### **Gabites Block Rezoning**

This document is to provide landscaping advice over the proposed development form at the Gabites Block in Upper Hutt.

Figure 2: Landscape features on the site.

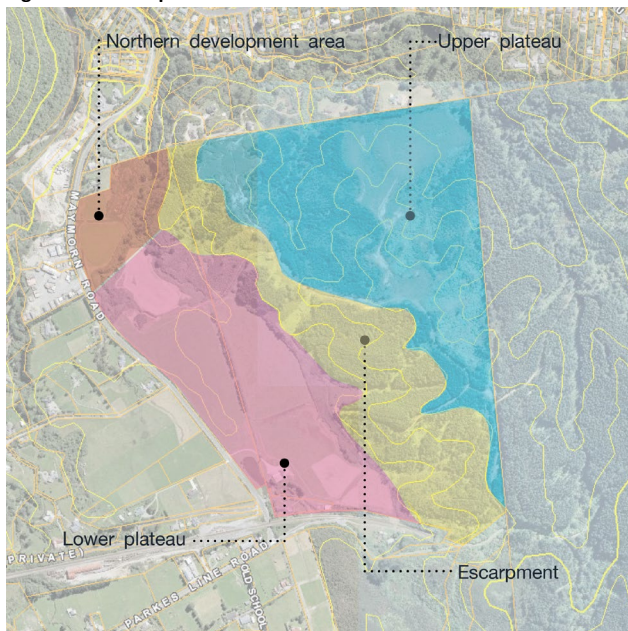
The site itself is 744 020m<sup>2</sup> in area and is comprised of the following four landscape features as marked in Figure 2 below:

- Lower Plain;
- Escarpment;
- Elevated Plateau; and
- Northern Development Area.
